STAFF REPORT

Re: DRAPER WINGATE HOTEL—SITE PLAN REQUEST

Application No.: SPR-979-2020
Applicant: Alan Melchior
Project Location: Approximately 12361 S Minuteman Drive
Current Zoning: CSD-DP (Draper Peaks Commercial Special District) Zone
Acreage: Approximately 2.4 Acres (approximately 104,500 square feet)
Request: Request for approval of a Site Plan in the CSD-DP (Draper Peaks Commercial Special District) Zone to remove the vacant restaurant building and construct a new four-story hotel along with a parking lot and landscaping improvements.

EXHIBIT E
SITE PLAN

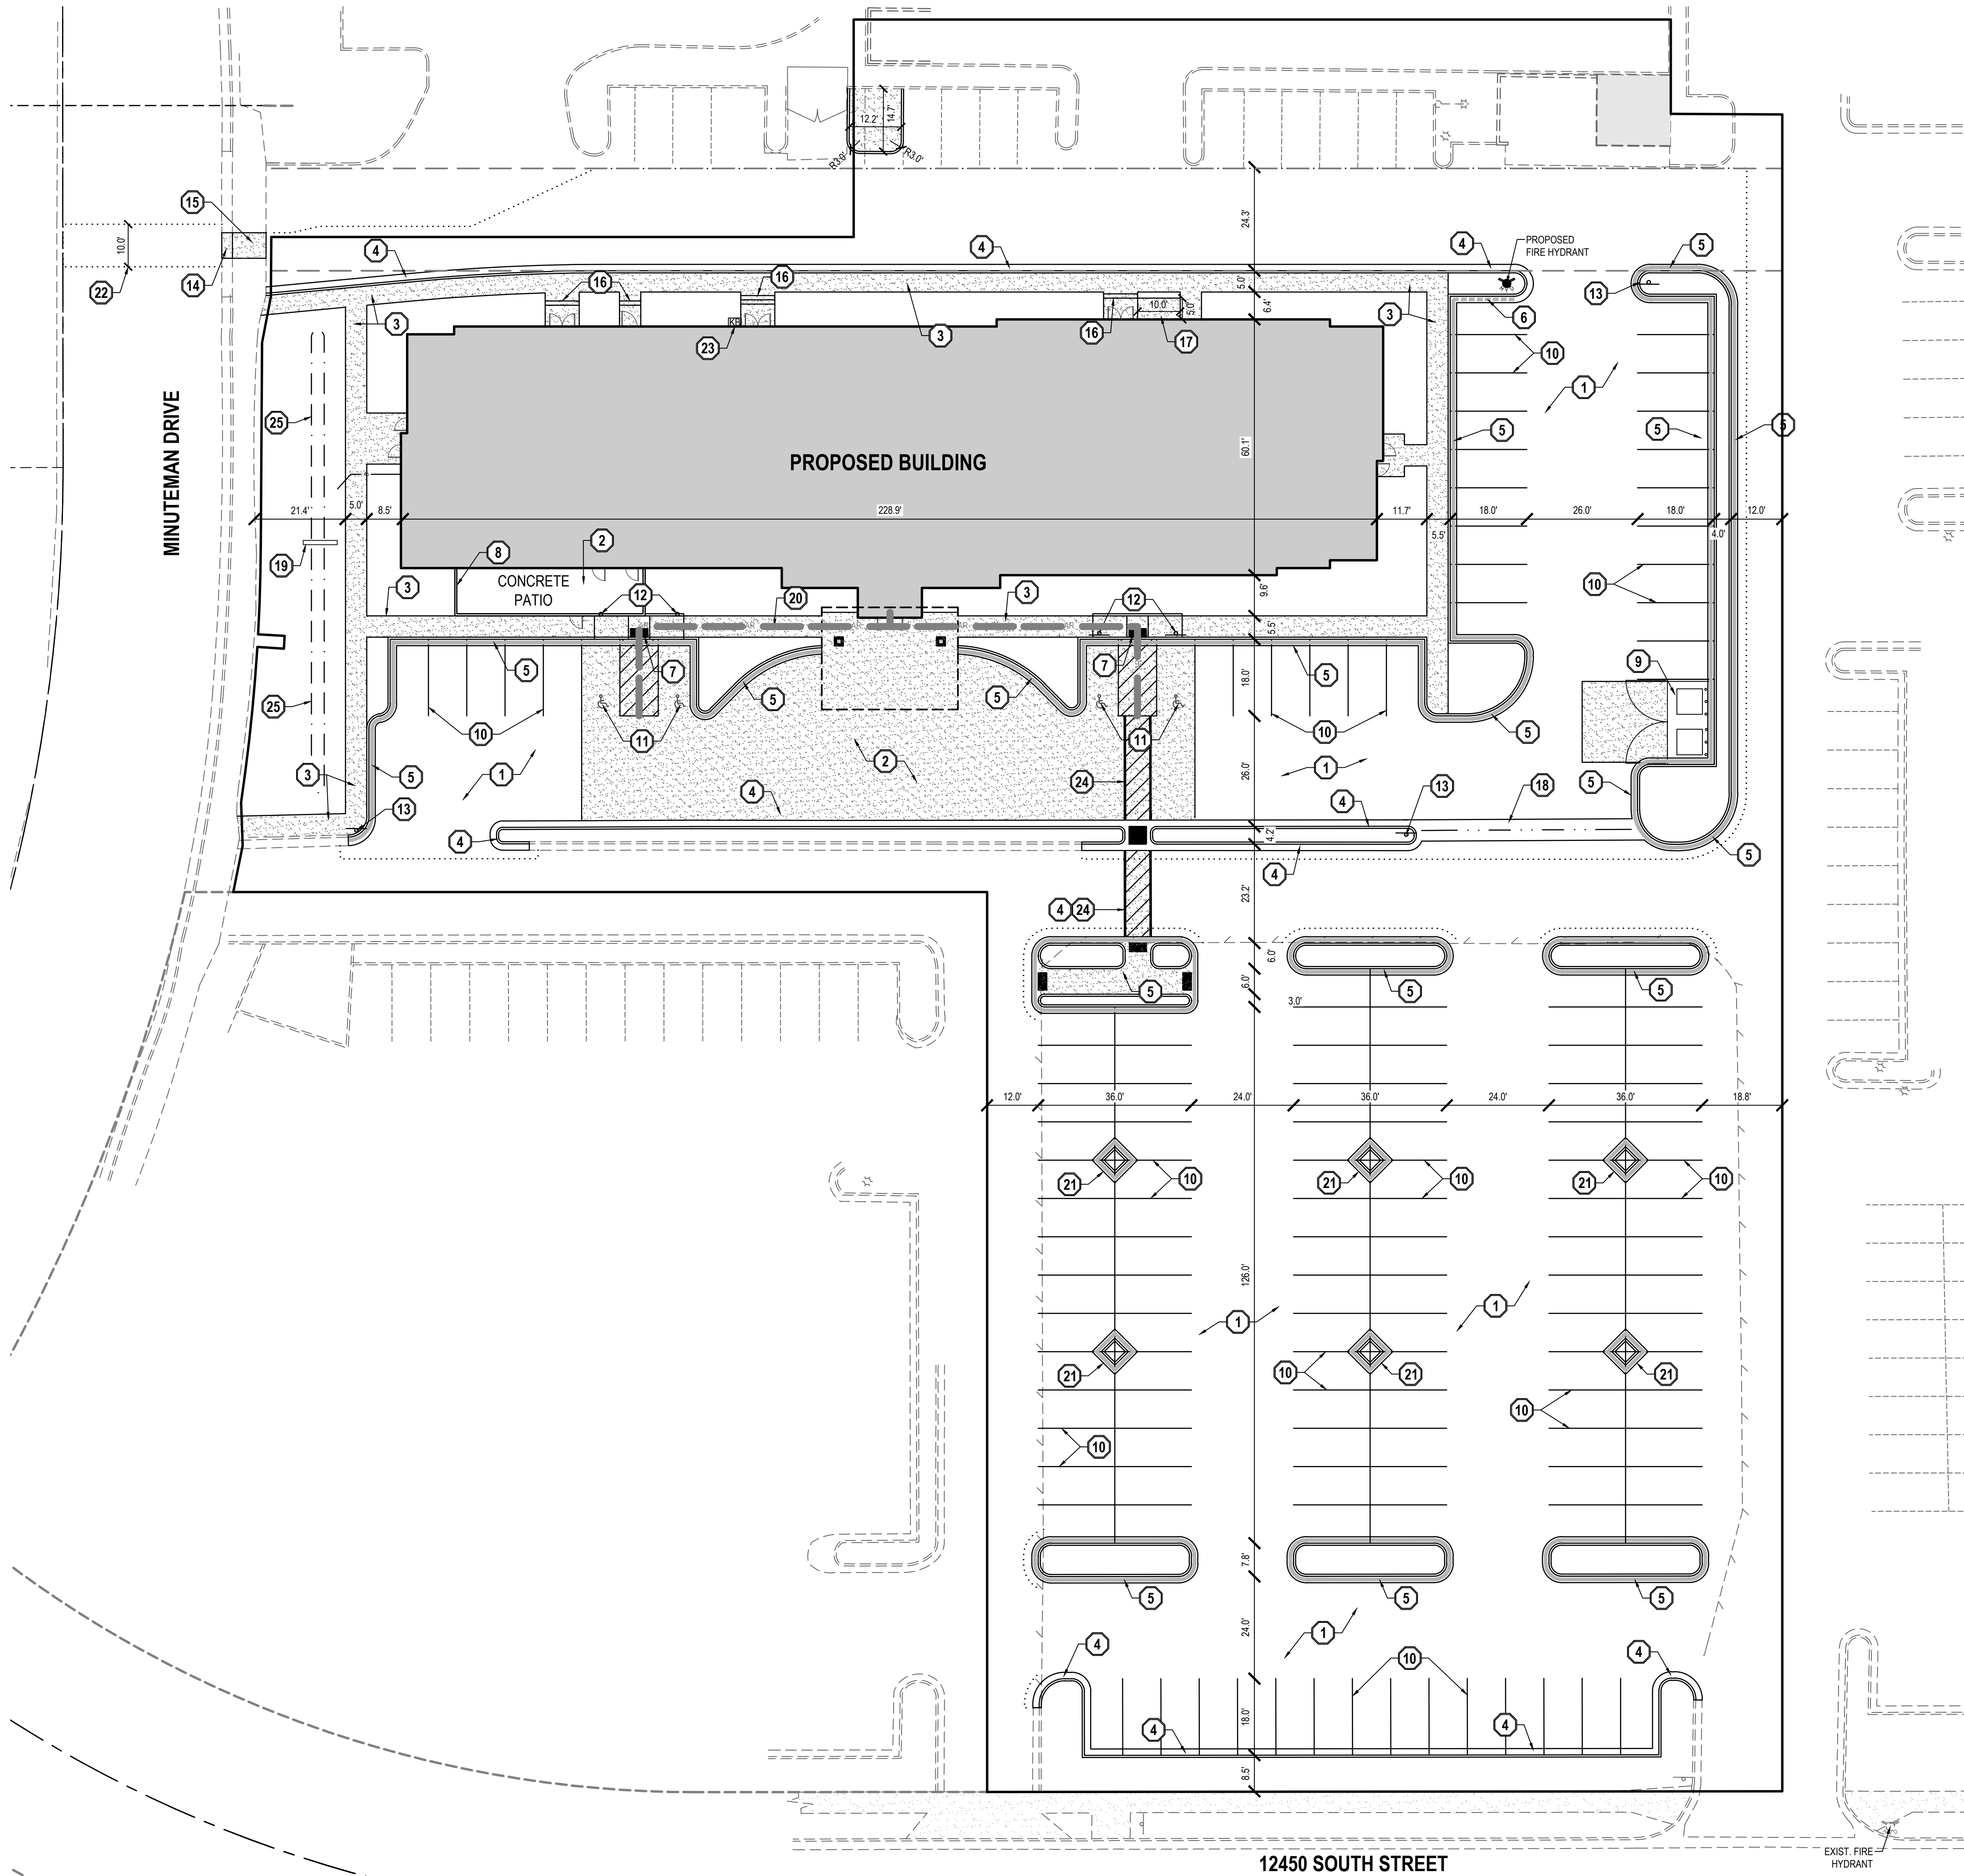
Site Plan Layout. The applicant is proposing to redevelop the site into a 98-room hotel (Exhibit E). The hotel building will be located on the north portion of the property where the existing restaurant building is located. Parking will be provided to the south and east of the hotel building. The ingress and egress points for the property will not be altered. Currently the site has an access point to Minuteman Dr. and two access points to Pioneer Road. All access points are shared with adjacent properties and the Draper Crossing development at large, including cross access and shared parking agreements.

Parking. The applicant is providing 137 parking spaces on the site. The code requires a hotel to provide one parking space per room, plus parking for any accessory uses like a restaurant. The hotel will contain 98 rooms and does not contain any accessory uses. The CSD-DP zone does not have a maximum amount of parking that is allowed. The applicant is looking into the possibility of eliminating a few of the spaces to allow for RV parking. The site has an excess of 39 parking spaces, the site can accommodate a slight change to the parking layout to accommodate RV parking.

1. Fire Department Access is required. An unobstructed minimum road width of twenty-six (26) feet exclusive of the shoulders and a minimum height of thirteen (13) feet six (6) inches shall be required. The road must be designed and maintained to support the imposed loads of emergency apparatus. The surface shall be able to provide all weather driving capabilities. The road shall have an inside turning radius of twenty – eight (28) feet. There shall be a maximum grade of 10%. Grades may be checked prior to building permits being issued. Due to the building height being more than thirty, (30) feet the fire code requires that the fire access lane width to be increased to 26 feet. This plan meets this requirement.

EXHIBIT F
LANDSCAPE PLAN

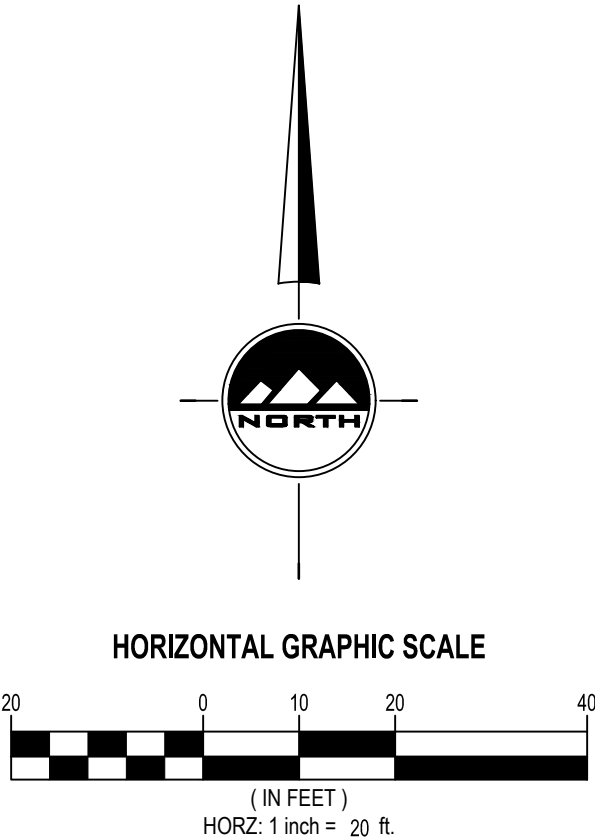
Landscaping and Lot Coverage. The development provides 12% overall landscaping at 12,468 square feet (Exhibit F). The building has a footprint of 9,745 square feet, a 10.5% property coverage amount. The CSD-DP zone does not stipulate a minimum amount of landscaping nor lot coverage. It does however require landscaping around buildings, along streets, and within parking lots. The proposed plans show extensive landscaping along its primary entrance to the site, Minuteman Dr. Landscaping is then provided around the building, at the end of parking rows, and along Pioneer Road. The parking lot contains tree diamonds as required within the CSD-DP zone. The site does contain a 500 square foot outdoor patio area. Additional amenities are located within the building, including a pool.

EXHIBIT G
ELEVATIONS

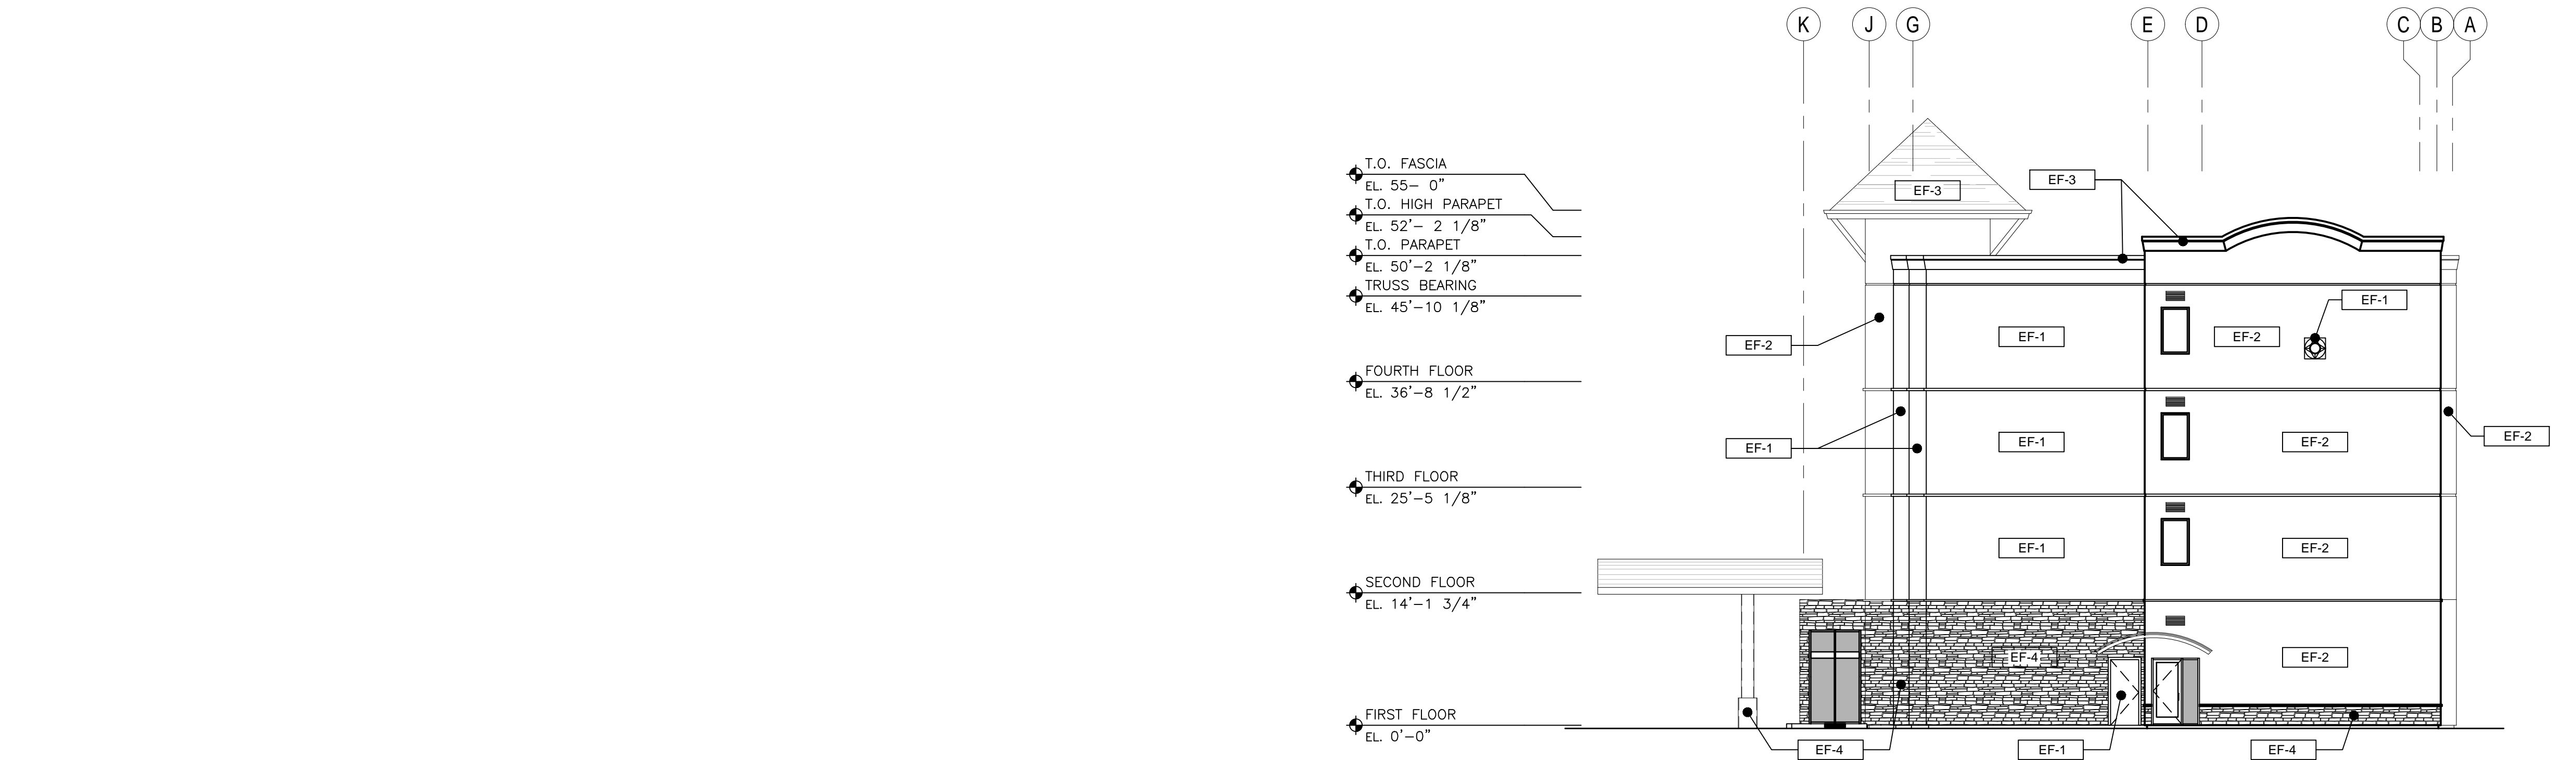
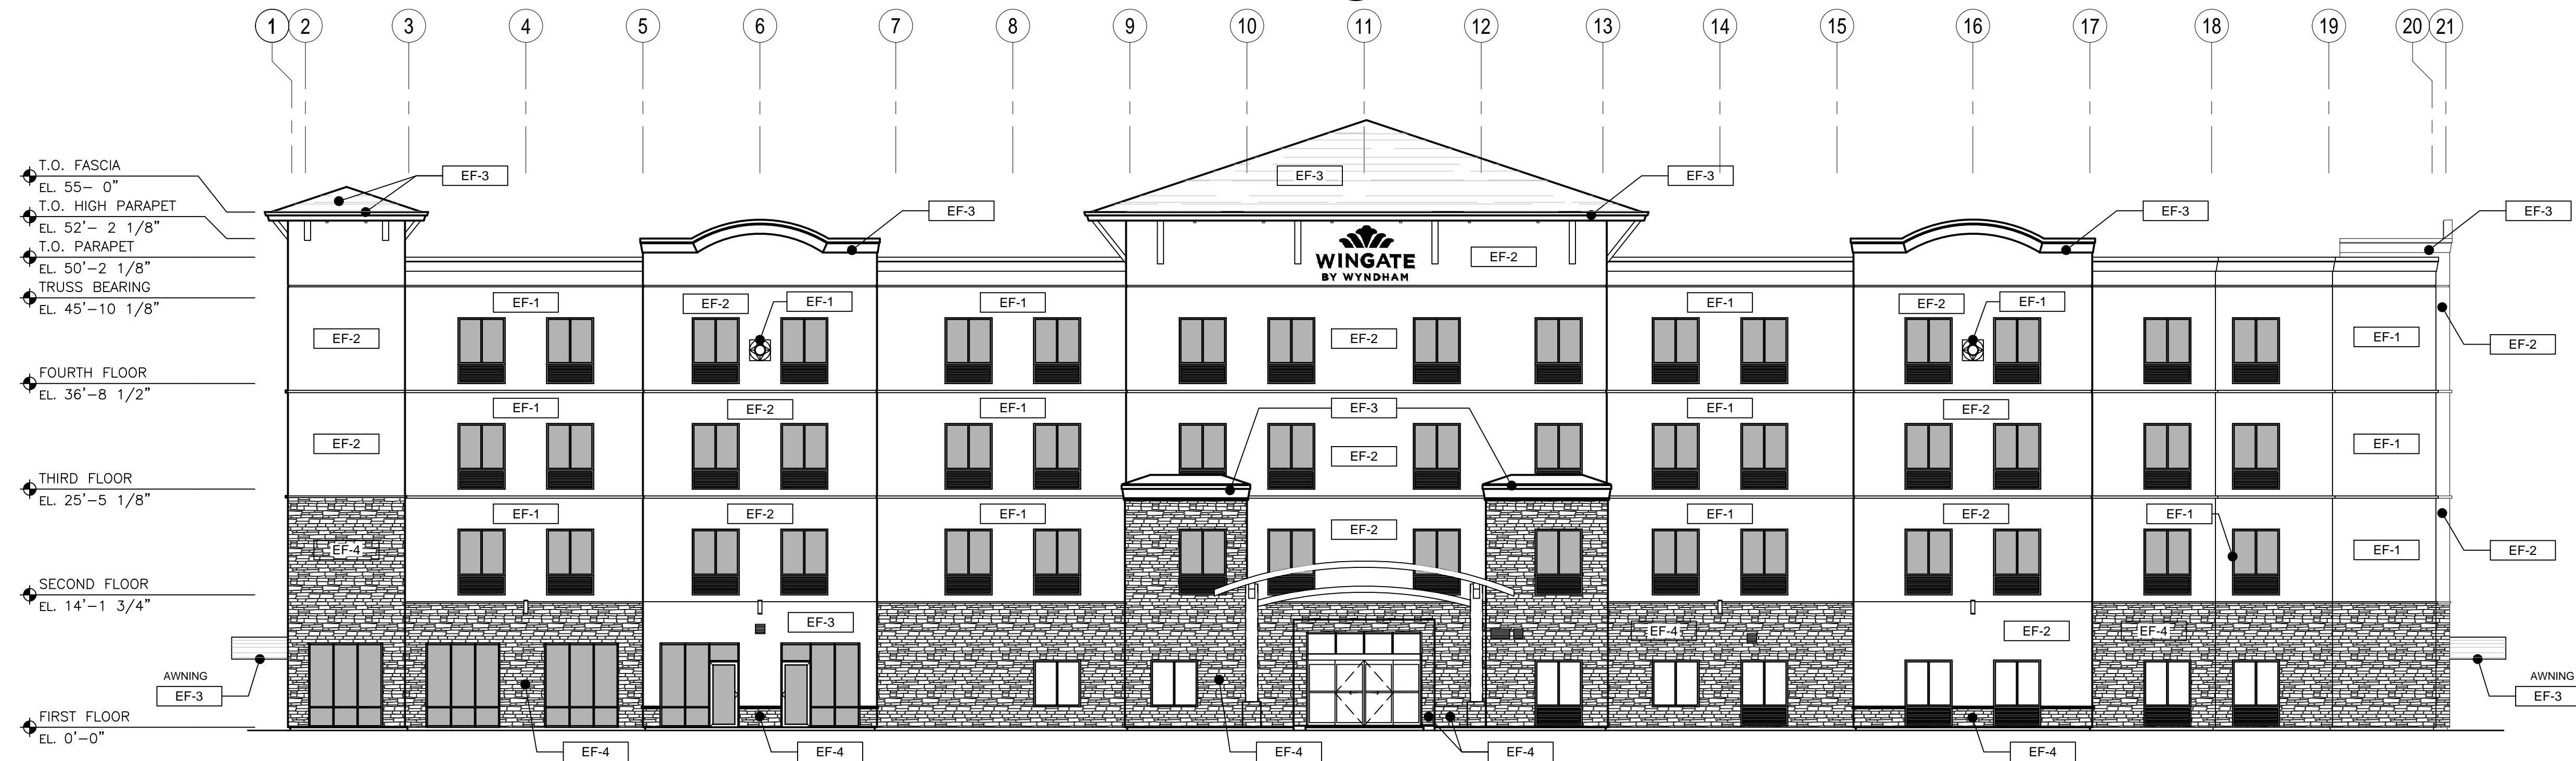
Architecture. The proposed hotel will contain four stories and be 55-feet tall (Exhibit G). The building’s roofline will contain two hipped roof features that will extend up to 11’ above the roofline. The building materials will be Exterior Insulation and Finish System (EIFS) and stone. The CSD-DP zone does not contain any minimum or maximum amounts of building materials. It does require buildings to match the architectural theme included in the exhibits to the zone and include stacked ledge stone. The architectural theme is the same for the entire Draper Peaks development, and includes the hipped roof features, stucco/EIFS materials, and stone.
